Appendix 2: Wagner Residence South Elevation Modification

FIG. 1 South Elevation facing Kenilworth Place

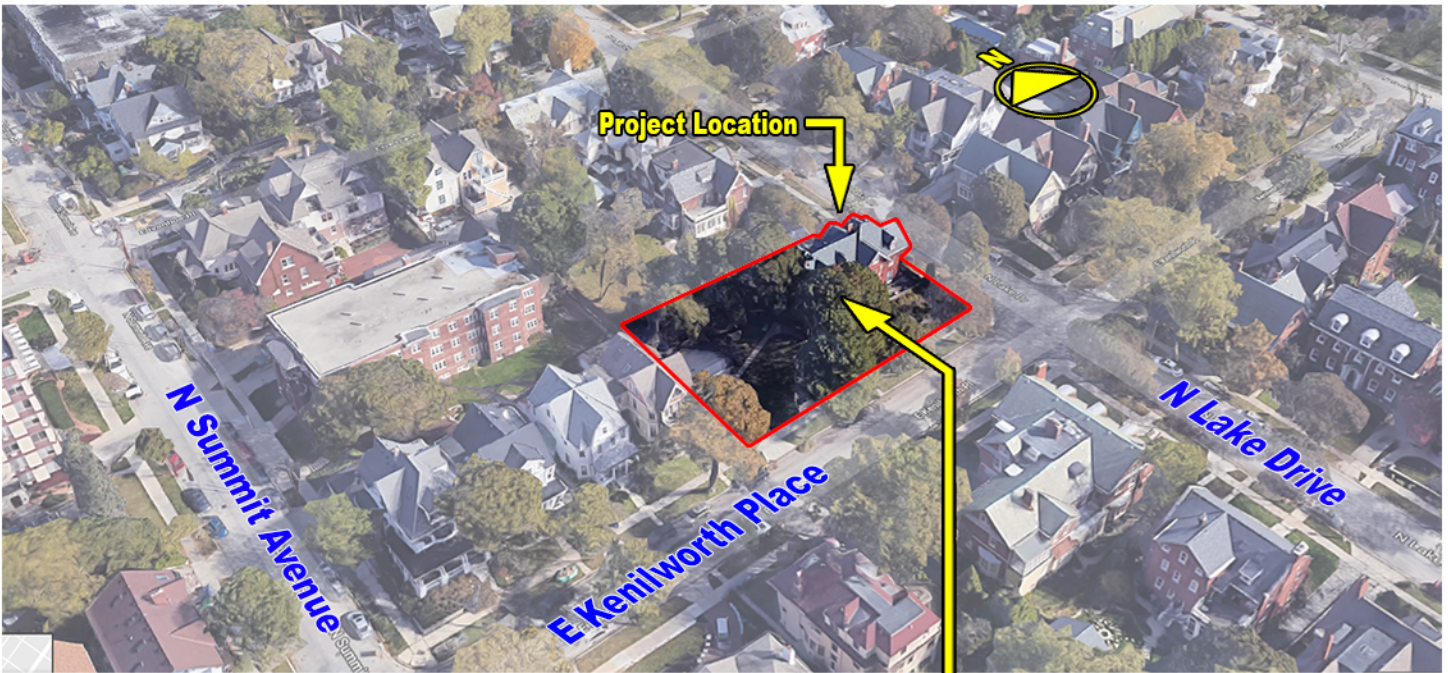
These three windows on the south elevation will be modified.

FIG. 2 Southwest corner of Ground Level

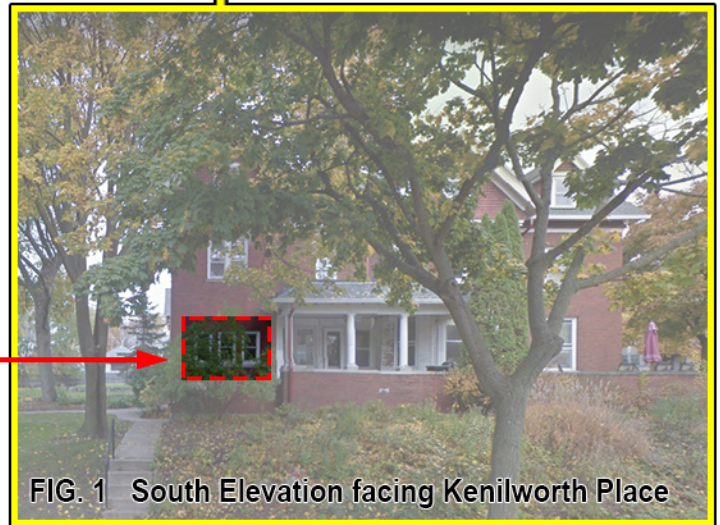
The head of the three windows will be raised to match adjacent windows around the corner. Existing windows will be replaced with new taller windows to match the head height of adjacent windows. New windows to match existing character and style. Existing window sills to remain as is.
